Proposed Revisions to a Standard Plans Index

Originator:	Turley, Joshua	Index Number:	715-010
Date:	5/17/2024	Sheet Number(s):	3
E-mail:	Joshua.Turley@dot.state.fl.us	Index Title:	HIGH MAST LIGHTING

HIGH MAST LIGHTING

INDEX 715-010	SHEET 3 of 6
------------------	-----------------

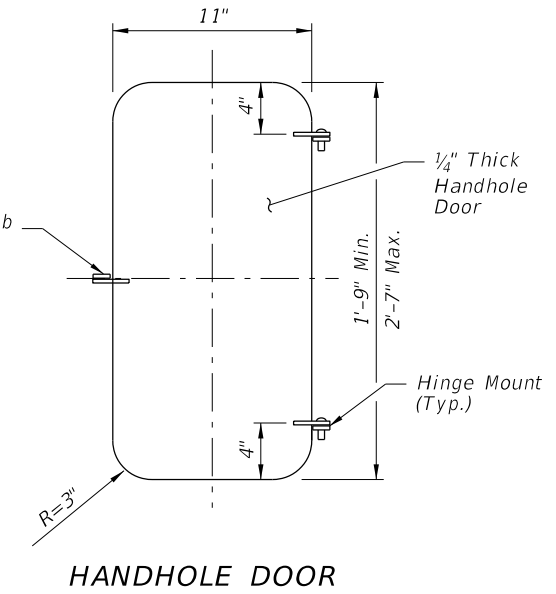
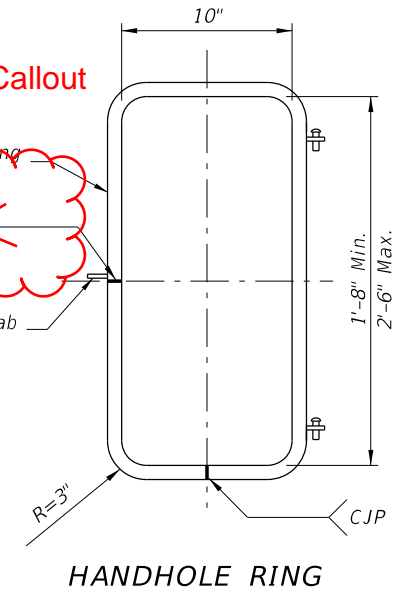
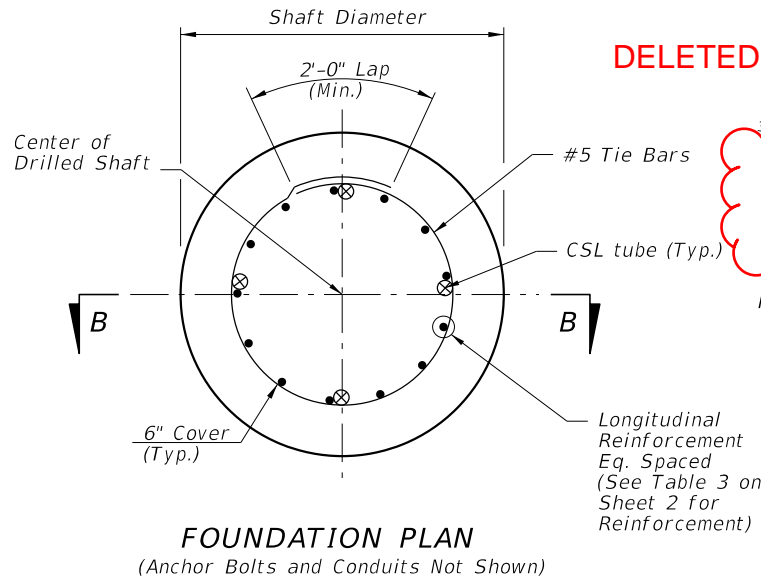
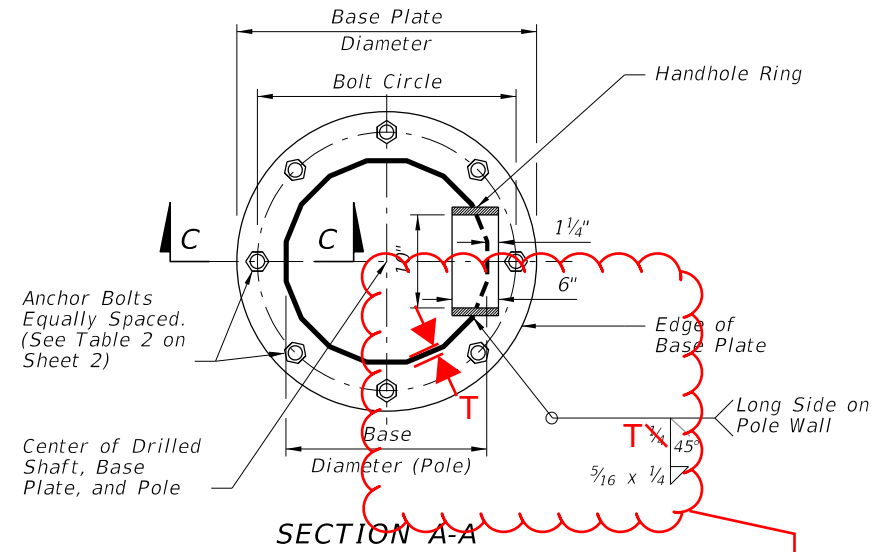
Sheet 3: SECTION A-A - Corrected weld detailing; HANDHOLE RING DETAIL - Removed superfluous CJP symbol. SECTION C-C - Removed weld hatching and updated weld symbol. Corrected order of anchor bolt nut labels. Corrected which nut may be half height and added thread extension min. SECTION D-D - Update wall thickness dimension and weld symbol.

These changes fix weld detailing errors and add clarity and brevity. There is an associated Spec change being drafted for Section 649 that pertains to process for tightening the anchor bolts. These changes make it so that the language aligns between the Spec and the Standard

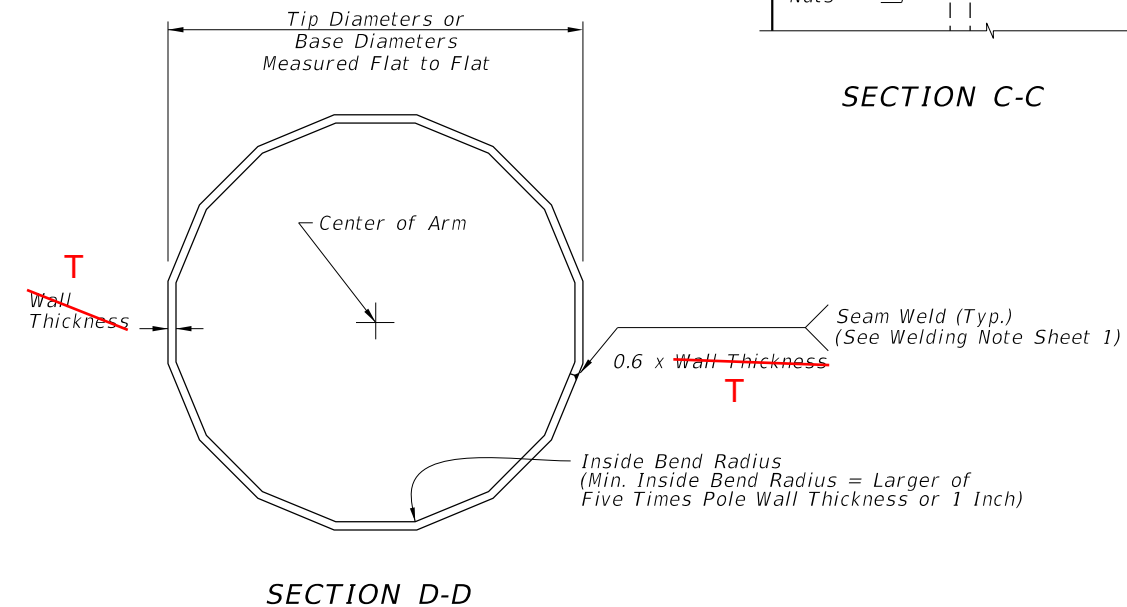
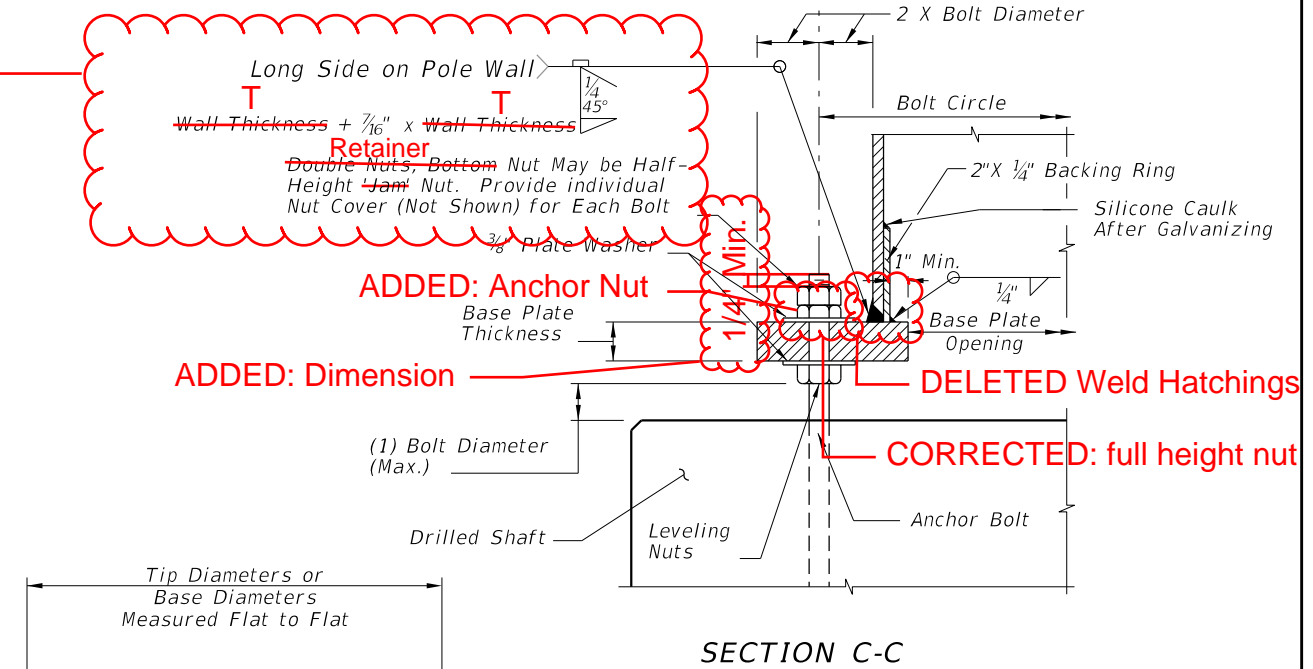
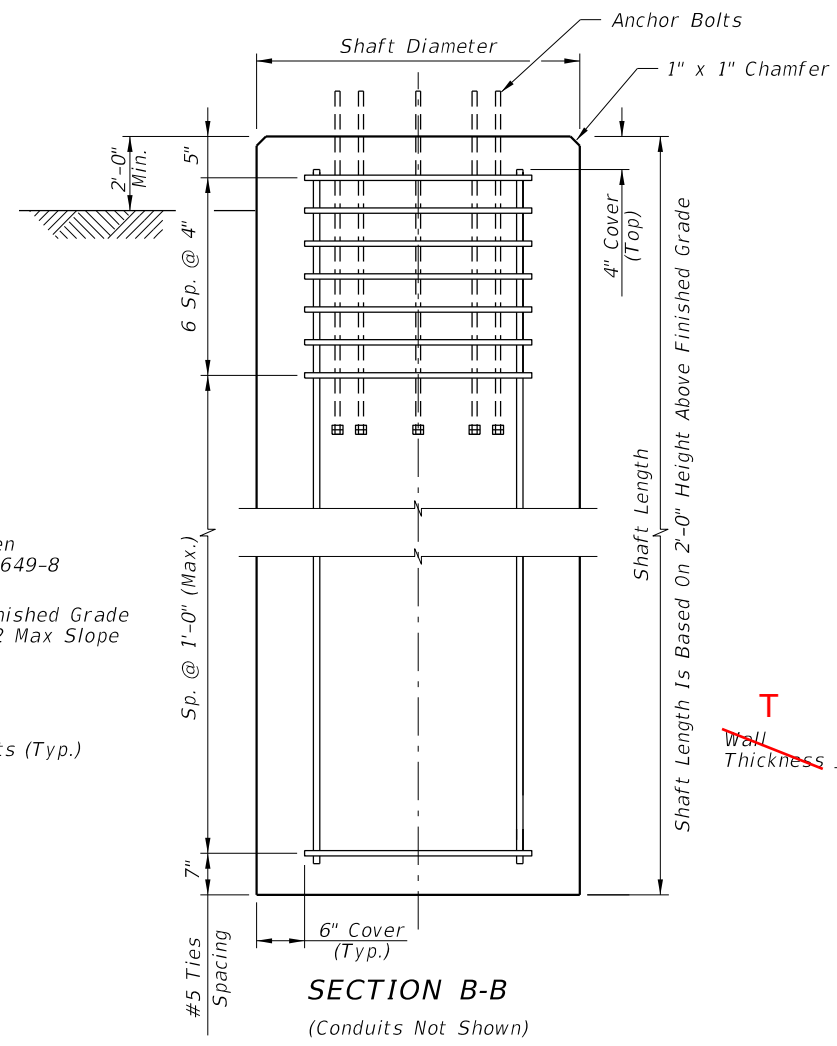
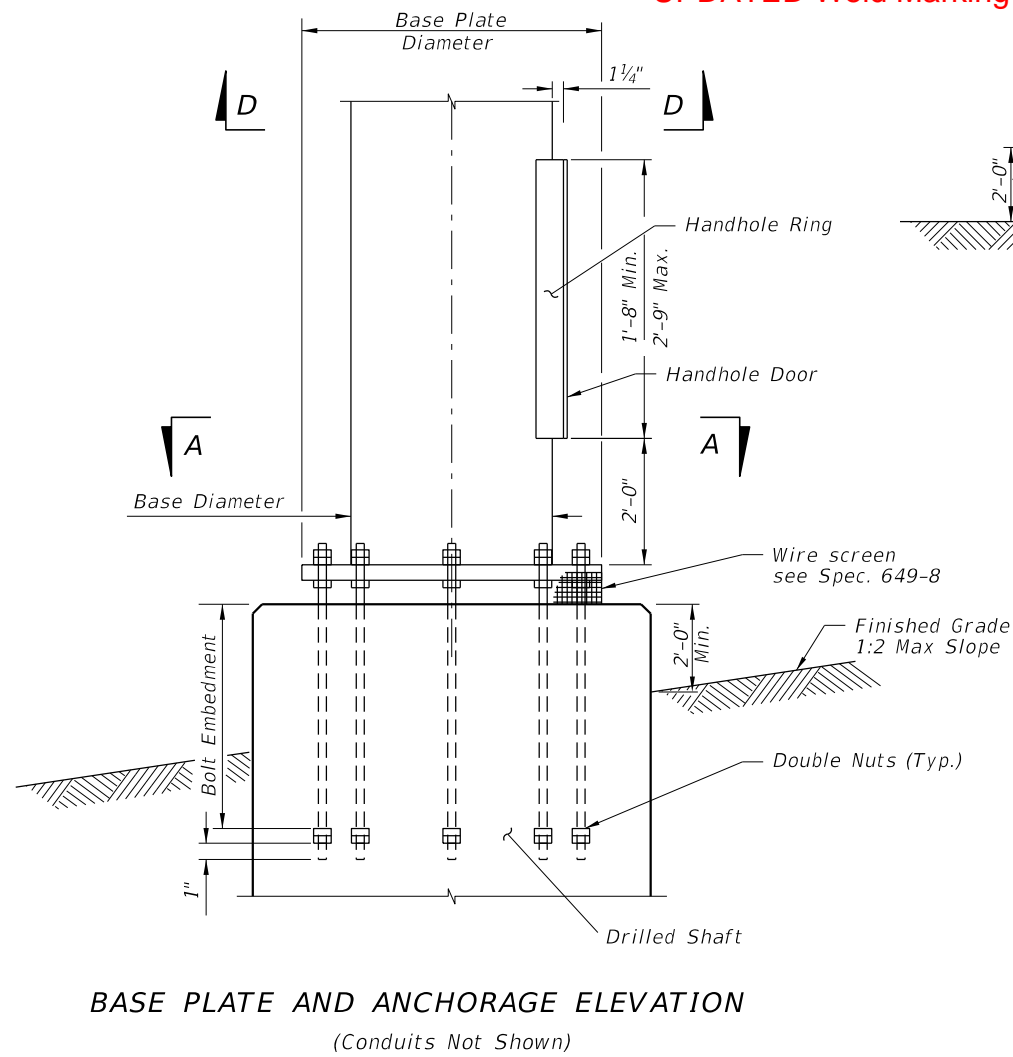
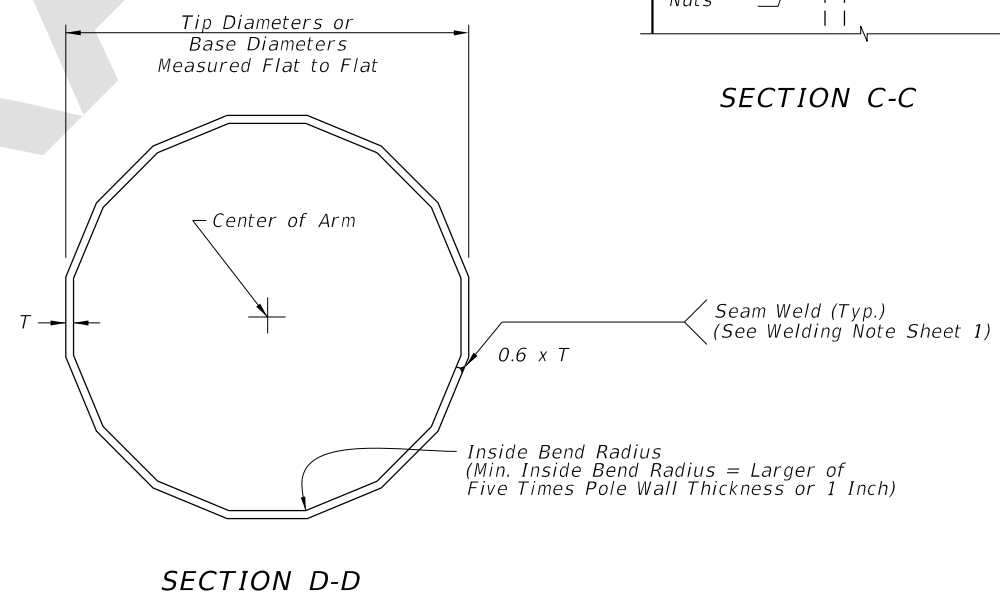
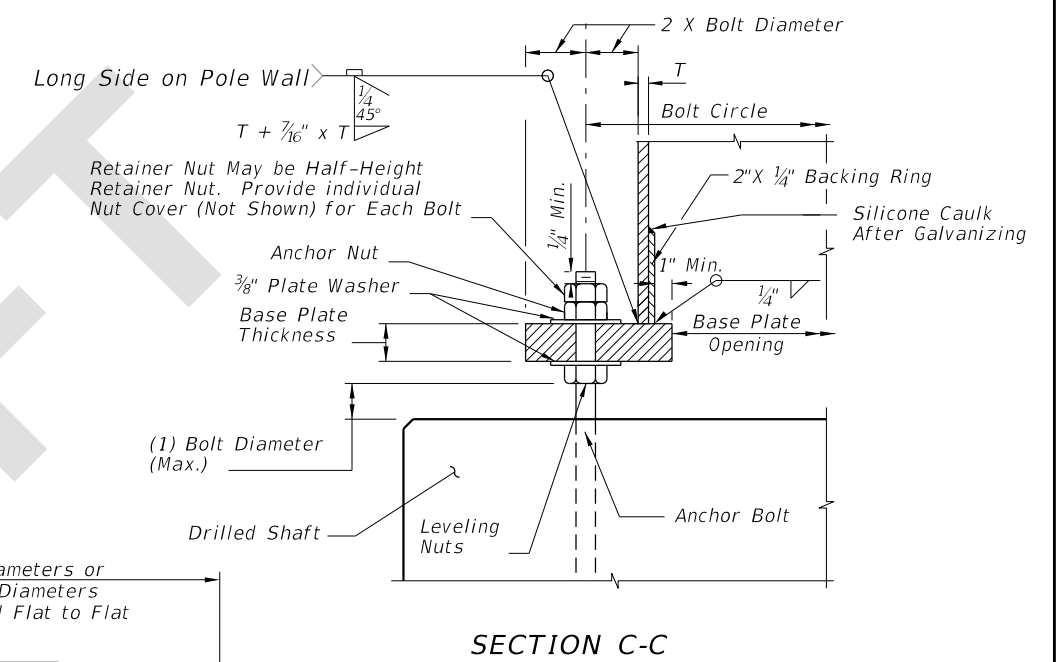
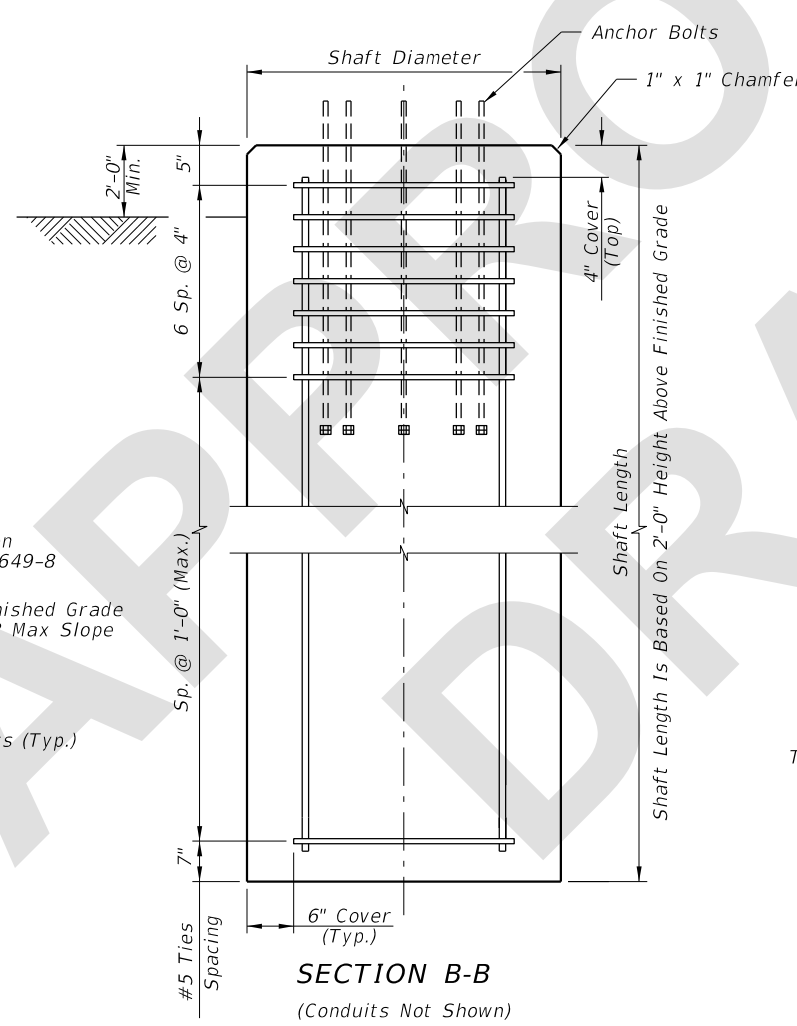
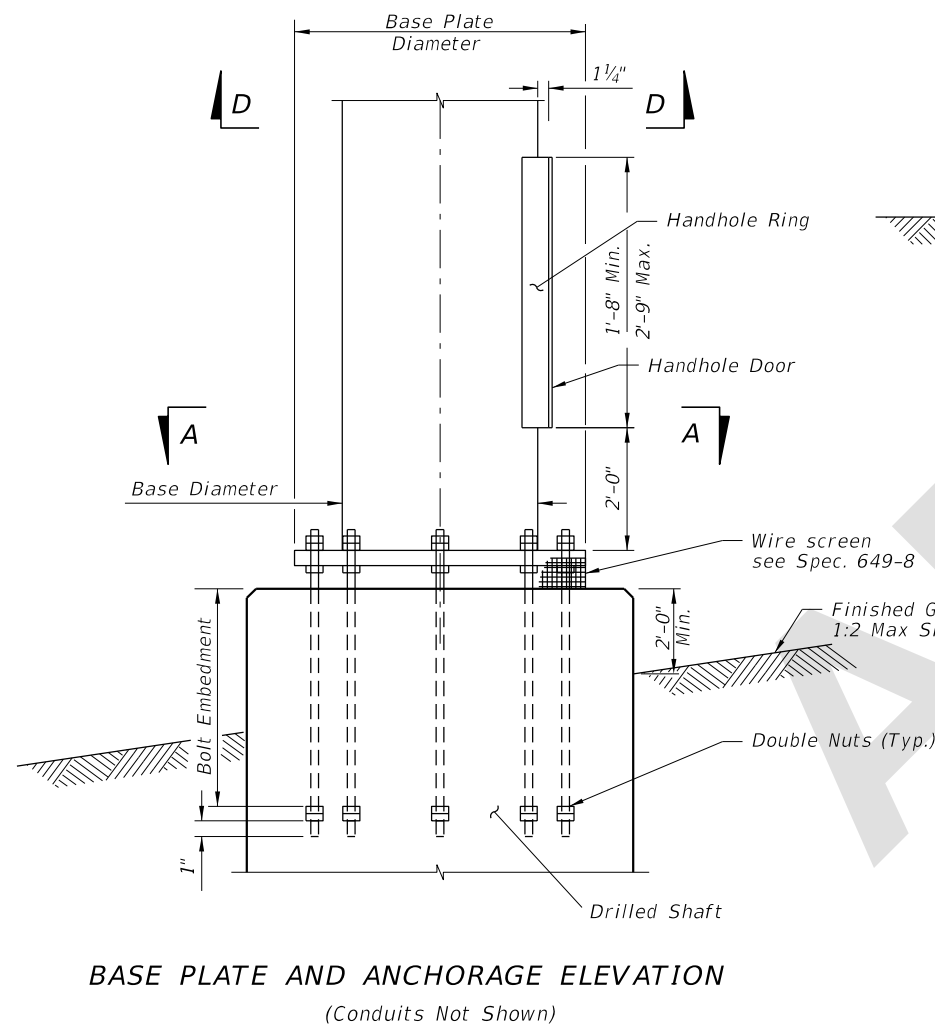
ADDED Dimension
UPDATED Weld Marking

UPDATED Weld Marking
UPDATED: Retainer Nut
